# Deepor Beel Railway Track Mitigation Plan

Mitigation measures for  
movement of Elephants from  
Rani and Garbhanga Reserve  
Forest to Deepor Beel across  
the Azara–Kamakhya Railway  
line in Guwahati, Assam

This mitigation plan was developed by Wildlife Institute of India based on request received from Northeast Frontier Railways to carry out a field visit for evaluating the suitability of the proposed mitigation measures on the second railway track vide letter No. W/362/Con/N-K/Misc./NGT; Dated 2<sup>nd</sup> July 2021.

**Figure 2.** Railway track, elephant corridors and mitigation measures proposed by NFR and recommended by WII for doubling of railway track between chainage 164/000 – 164/200 of the Azara – Kamakhya railway line passing through the southern boundary of Deepor Beel, Guwahati, Assam.

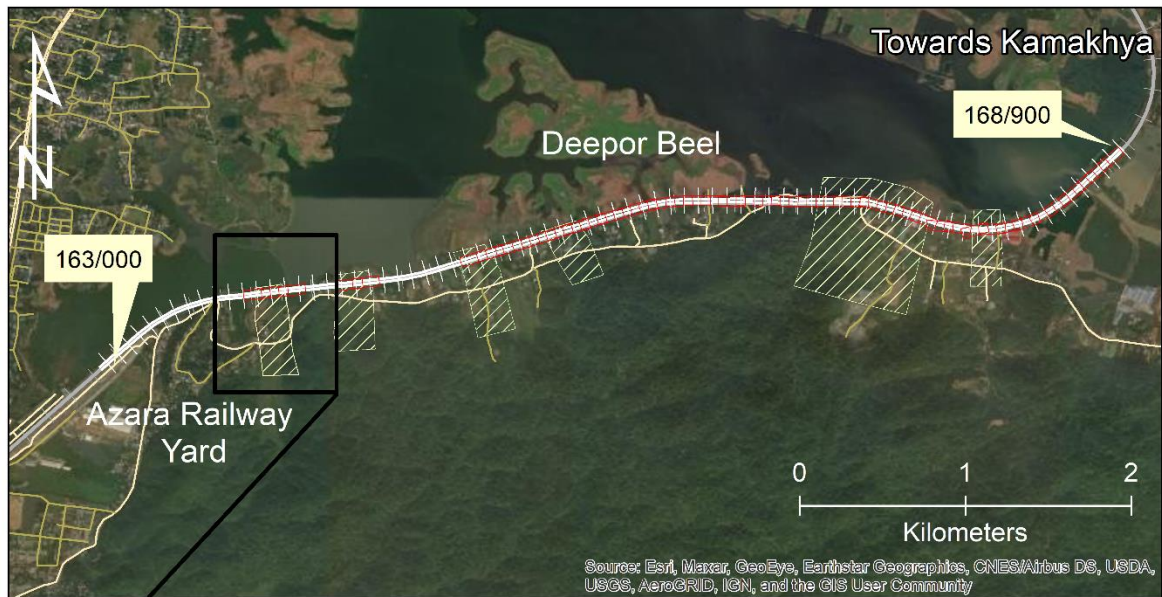
One mitigation structure (RCC box) measuring 200 m wide and 7 m high has been proposed on the first corridor (Chainage 164/000 – 164/150). Additionally, an underpass measuring 150 m wide and 7 m high on the road parallel to the railway track is recommended. It is also recommended to install guide walls to direct animal movement first towards the road underpass and then towards the railway track underpass. ***It is recommended to construct the underpasses as RCC structures with a span of 12 m and pillar-type divisions.*** The details of the proposed and recommended mitigation measures are provided in Table 2 and Figure 2.

**Figure 3.** Railway track, elephant corridors and mitigation measures proposed by NFR and recommended by WII for doubling of railway track between chainage 164/500 – 164/600 of the Azara – Kamakhya railway line passing through the southern boundary of Deepor Beel, Guwahati, Assam.

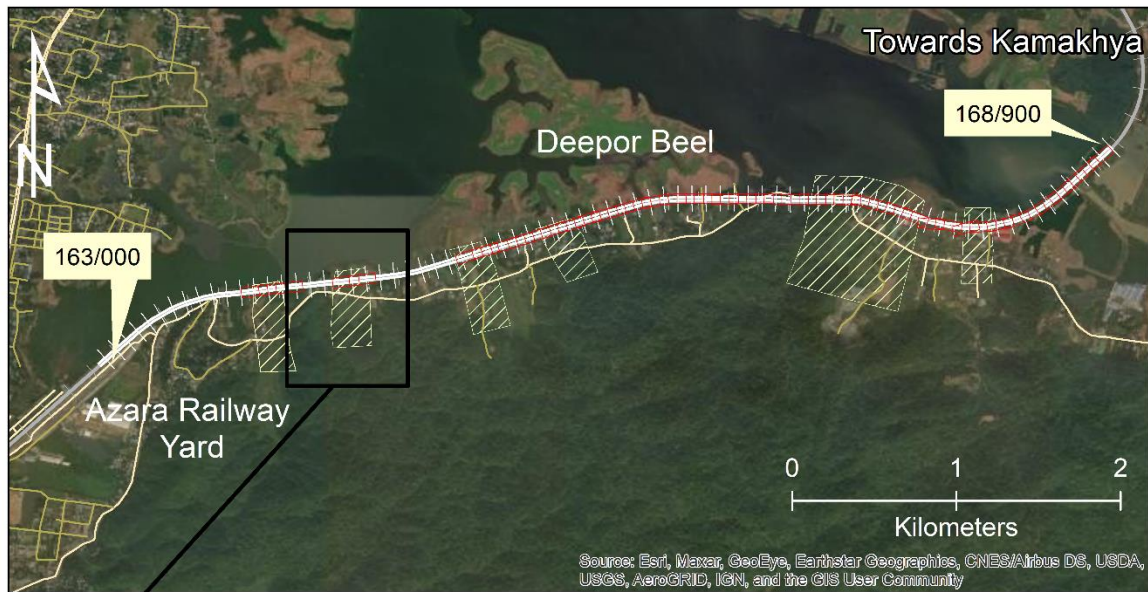
One mitigation structure (RCC box) measuring 100 m wide and 7 m high has been proposed on the second corridor (Chainage 164/400 – 164/600). Additionally, an underpass measuring 100 m wide and 7 m high on the road parallel to the railway track is recommended. It is also recommended to install guide walls to direct animal movement first towards the road underpass and then towards the railway track underpass. ***It is recommended to construct the underpasses as RCC structures with a span of 12 m and pillar-type divisions.*** The details of the proposed and recommended mitigation measures are provided in Table 3 and Figure 3.

**Figure 4.** Railway track, elephant corridors and mitigation measures proposed by NFR and recommended by WII for doubling of railway track between chainage 165/200 – 165/300 of the Azara – Kamakhya railway line passing through the southern boundary of Deepor Beel, Guwahati, Assam.

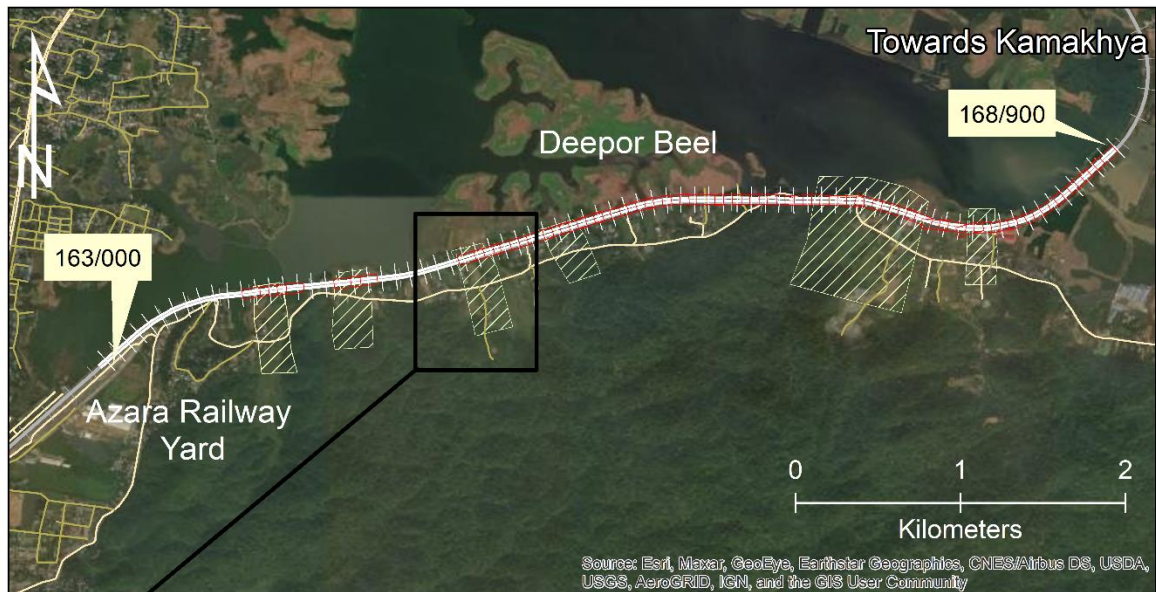
One mitigation structure (RCC box) measuring 100 m wide and 7 m high has been proposed on the third corridor (Chainage 165/100 – 165/300). Additionally, an underpass measuring 100 m wide and 7 m high on the road parallel to the railway track is recommended. It is also recommended to install guide walls to direct animal movement first towards the road underpass and then towards the railway track underpass. ***It is recommended to construct the underpasses as RCC structures with a span of 12 m and pillar-type divisions.*** The details of the proposed and recommended mitigation measures is provided in Table 4 and Figure 4.

**Figure 6.** Additional mitigation measures recommended in the first segment (chainage 165/950 – 166/050) of the 3500 m ling viaduct on the Azara – Kamakhya railway line passing through the southern boundary of Deepor Beel, Guwahati, Assam.

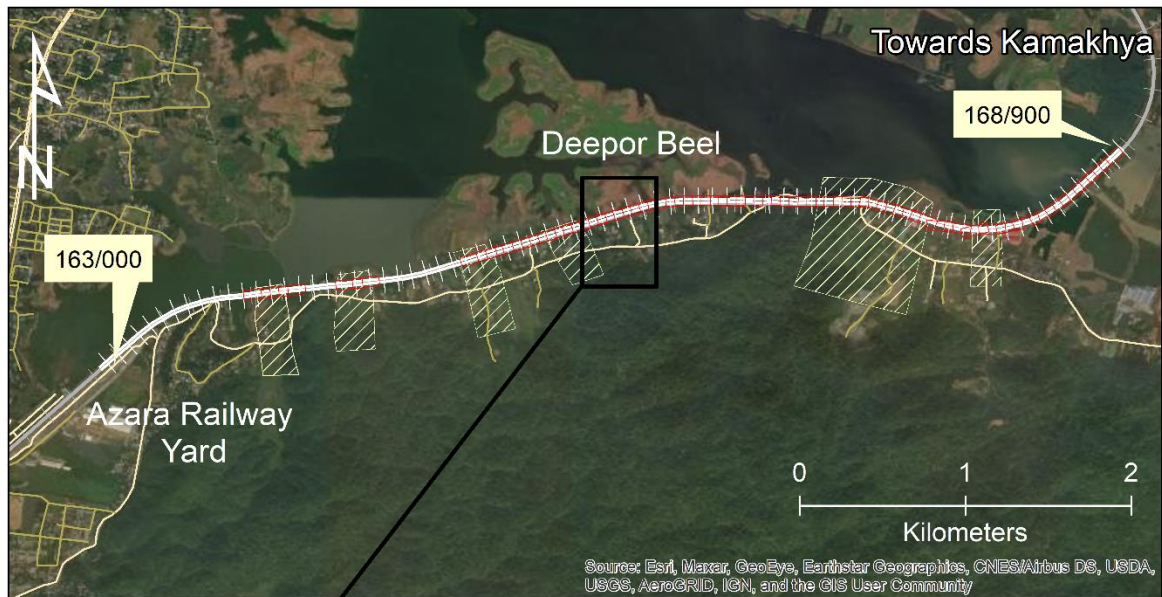
An underpass measuring 100 m wide and 7 m high on the road parallel to the railway track is recommended. It is also recommended to install guide walls to direct animal movement first towards the road underpass and then towards the viaduct on the railway track. The details of the proposed and recommended mitigation measures is provided in Table 6 and Figure 6.

**Figure 7.** Additional mitigation measures recommended in the second segment (chainage 166/850 – 167/380) of the 3500 m ling viaduct on the Azara – Kamakhya railway line passing through the southern boundary of Deepor Beel, Guwahati, Assam.

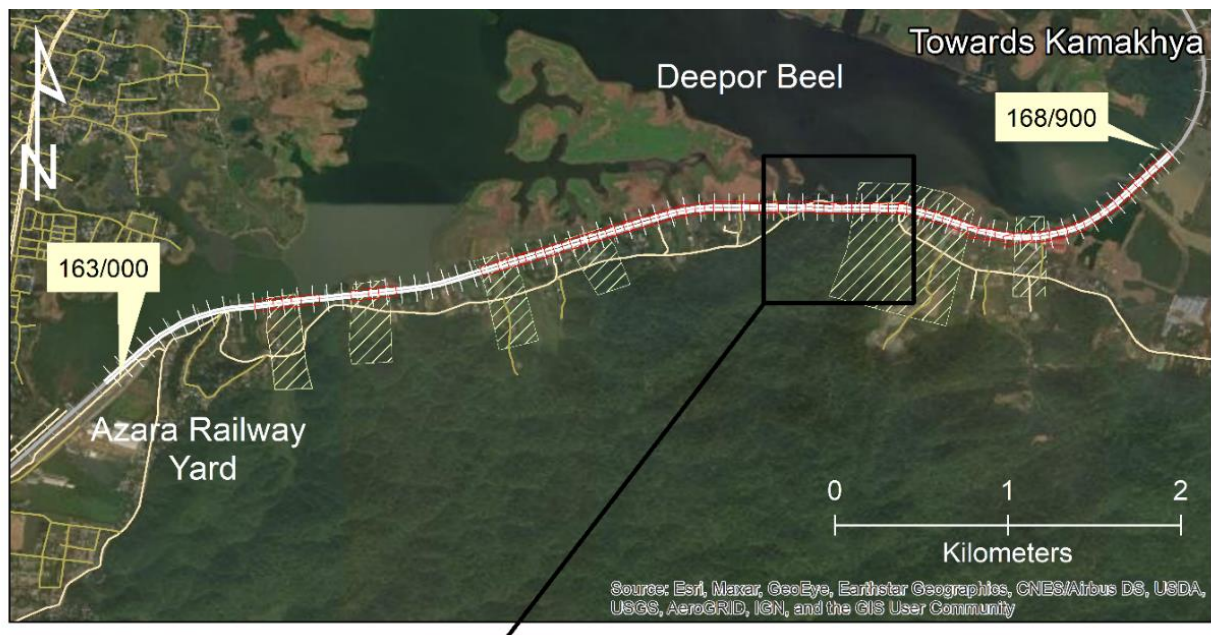
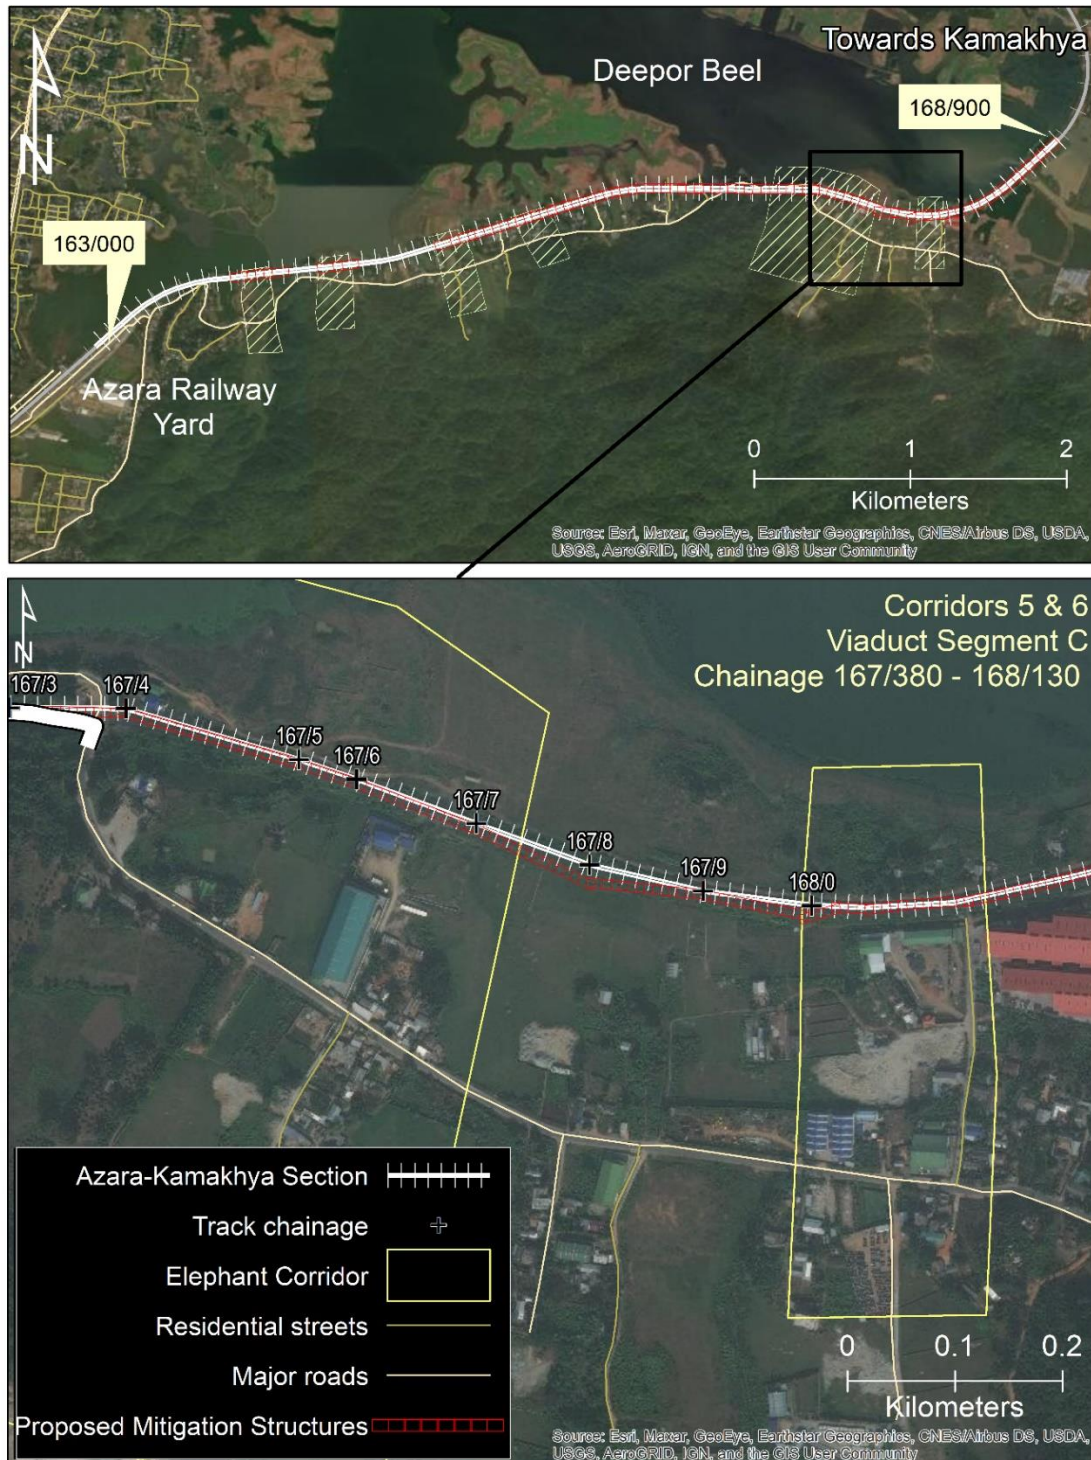
It is recommended to elevate the road section between the two level crossings (chainages 166/850 and 167/380) presently crossing over to the north of the railway track (Figure 7). The road must be elevated and brought to the south of the present alignment. The length of the road between the two level crossings is 520 m. The height of the road underpass should be the same as that of the viaduct for the entire stretch (7 m). The details of the proposed and recommended mitigation measures is provided in Table 7 and Figure 7.

**Figure 9** (a) Wall-type division of bridge and (b) pillar-type division

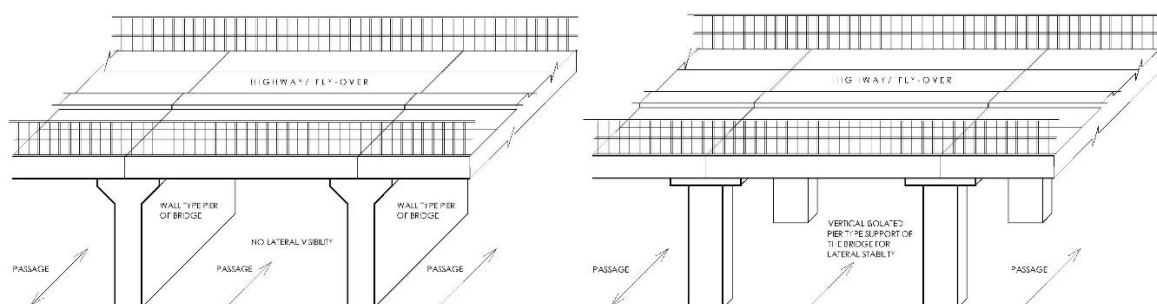
- i. Guide walls are recommended to direct animal movement towards the underpasses.
- ii. The width of individual spans on all crossing structures (road and railway) should be 12 m wide (instead of 5 m wide RCC box).
- iii. The divisions of the crossing structures measuring 100 – 200 m should be of pillar type (instead of wall-type, Figure 9 a and b) with 1.5 m diameter.
